IEEE P802.15
Wireless Personal Area Networks

Project	IEEE P802.15 Working Group for Wireless Personal Area Networks (WPANs)	
Title	TG3 SB1 comment resolution	
Date Submitted	[23 January, 2003]	
Source	[James P. K. Gilb] [Apparent Technologies] [15373 Innovation Drive, #210, San Diego, CA 92129]	Voice: [858-485-6401] Fax: [858-485-6406] E-mail: [gilb@ieee.org]
Re:	[]	
Abstract	[This document is a record of comment resolutions for SB1.]	
Purpose	[To provide a record of the comment resolution for SB1.]	
Notice	This document has been prepared to assist the IEEE P802.15. It is offered as a basis for discussion and is not binding on the contributing individual(s) or organization(s). The material in this document is subject to change in form and content after further study. The contributor(s) reserve(s) the right to add, amend or withdraw material contained herein.	
Release	The contributor acknowledges and accepts that this contribution becomes the property of IEEE and may be made publicly available by P802.15.

1. Conference calls

Figure 2—MSC for the handing over control of a private, pseudo-static CTA

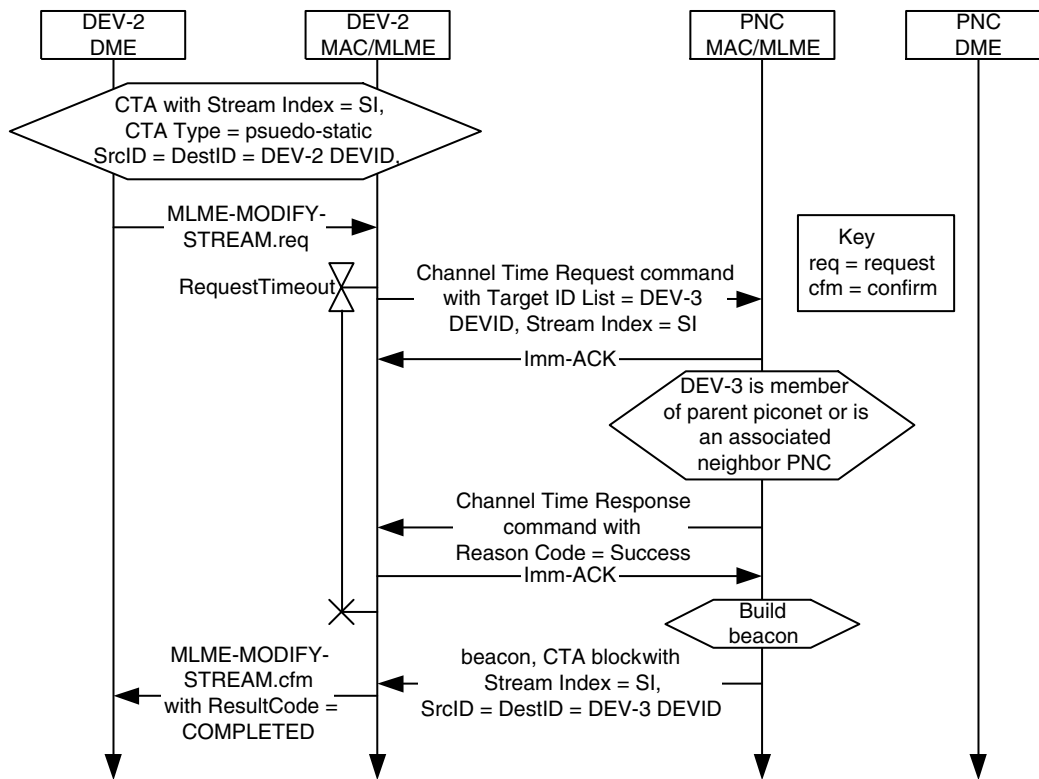
CID 216 - The paragraph seems to assume behaviors of equipment which don't exist- and can't exist without some kind of a PAR in 802.11. 802.11 AP's (not 11b AP's) do not have any optional or normative ability to request neighbor piconet status. And, change the paragraph to "802.11 overlapping with 802.15.3..." Remove the paragraph. However, coexistence in time CAN be accomdated if the INFORMATION element that was approved (see 802.15.2 coexistence) is used by the 2.4GHz AP. Please state something to that effect. Suggest accept in principle "Add to the end of the paragraph the following text: 'This capability is not specified in the 802.11 standard and so this would require an AP that had additional functionality that is outside of the current 802.11 standard. The IEEE 802.15.2 recommended practice has proposed an information element and extra functionality that, if added the 802.11 standard, would make it possible to build a standards compliant AP that could then support neighbor piconet capability.'"

Add new text to 8.5.1.2,

If the target DEV indicated in the Target ID List is either a member of the parent piconet or is a associated neighbor PNC and the Channel Time Request command has the correct entries as indicated above, the parent PNC shall grant the request to change the source and destination for the stream and shall send a Channel Time Response command to the originator with the Reason Code set to 'Success'. The PNC shall continue to place the CTA block for the allocation in the beacon but shall change the SrcID and DestID to be equal to the target's DEVID. Once the PNC has changed the SrcID and DestID in the CTA block, the target DEV will

have gained control of the CTA and will be allowed to request modifications or the termination of the allocation.

If the target DEV is not a member of the piconet and it is not an associated neighbor PNC, the parent PNC shall reject the request and shall send a Channel Time Response command to the originator with the Reason Code set to either 'DEV unassociated' or 'DEV unauthenticated' depending on the status of the Target DEV.

If the Channel Time Request command has improper entries, e.g. the Stream Index does not exist or the Stream Index is not associated with a private, pseudo-static CTA, then PNC shall reject the request and shall send a Channel Time Response command to the originator DEV with the Reason Code set to 'Request denied'.

The MSC for the handover of the control of a private, pseudo-static CTA is illustrated in Figure 2.

Figure 3—Channel time request for frames with immediate ACKs

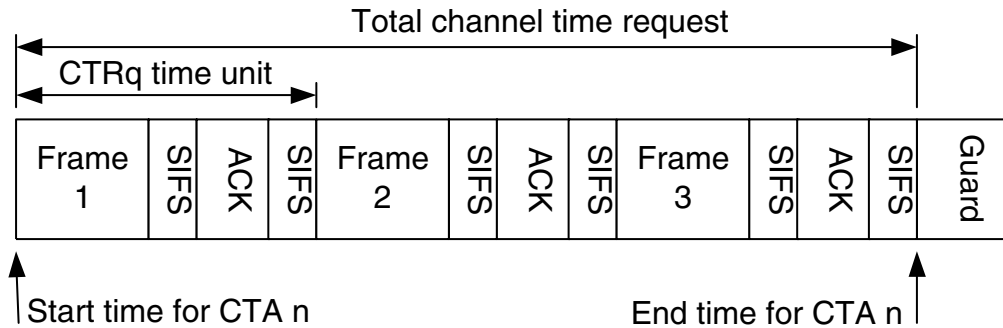
CID 682: - **Suggest accept in principle:** The inclusion of MIFS changed the CTR calculations, but the changes were not reflected in 8.4.4.6. '1)Change b3 in Figure 79 from "stream termination" to "MIFS CTRq TU". 2)Replace page 152, line 12 with:

The requesting DEV shall include the frame transmission time, if known *a priori*, and the ACK transmission time, if used, and MIFS or SIFS time as appropriate per frame or ACK when calculating channel time

requests. Figure 3 (was #108) shows an example of channel time being requested for a CTA where Imm-ACKs are used.
